CHELTONHAM DRIVE BIKEWAY

MANDATORY REFERRAL NO. MR2026005

COMPLETED: 12/4/2025

PLANNING BOARD HEARING DATE: 12/11/2025

Figure 30: Potential Mountable Apron Design

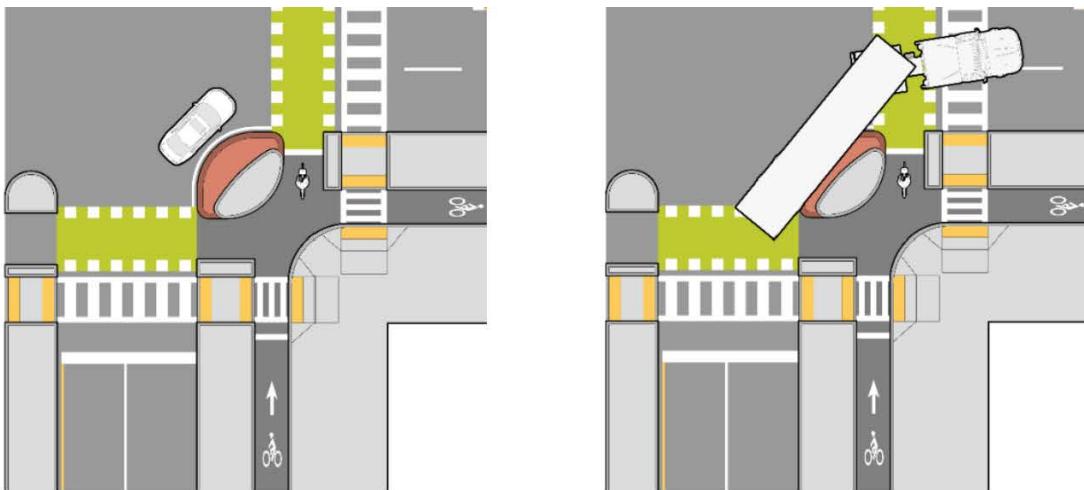
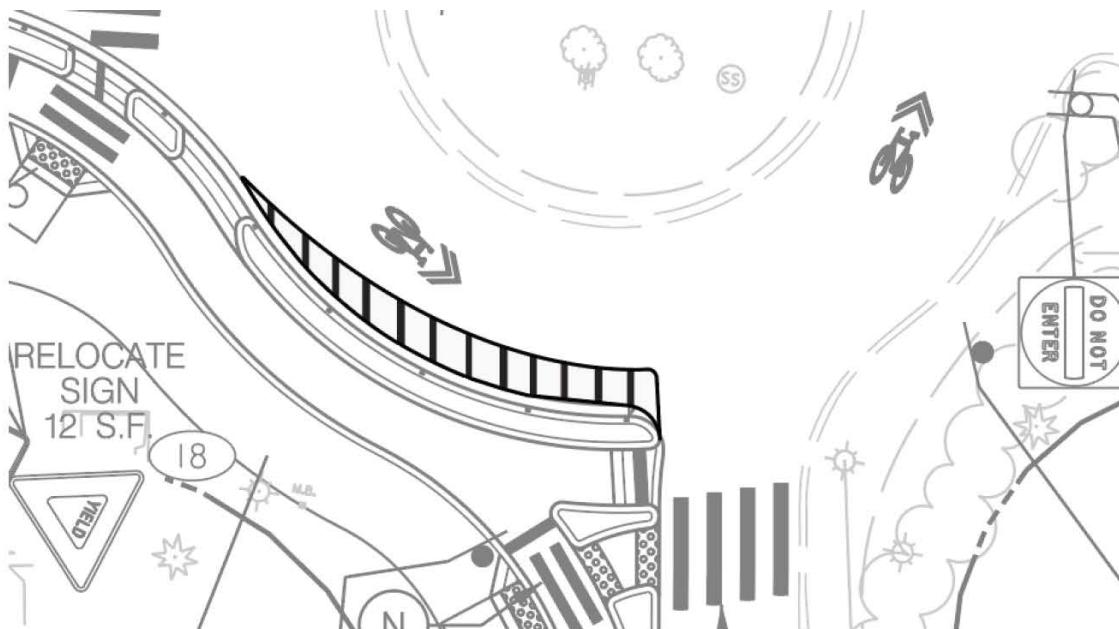
2) **Construct a mountable apron on the outer edge of the southwest corner of the roundabout.**

Mountable aprons are curbing used within roundabouts and protected intersections to constrain the movement of most vehicles while still allowing access for larger vehicles, like buses or trucks. Typically, the mountable apron is provided on the inner curb of the roundabout (the side of the travel lane nearest the center of the circle), but in this case, constructing it on the outside would guide motor vehicles farther away from the bikeway, providing some additional separation between merging bicyclists and motor vehicles. Figure 29 shows how mountable aprons guide automobile movements while maintaining access for larger vehicles. Figure 30 shows what a mountable apron could look like in the Tilbury Street roundabout using vertical black stripes.
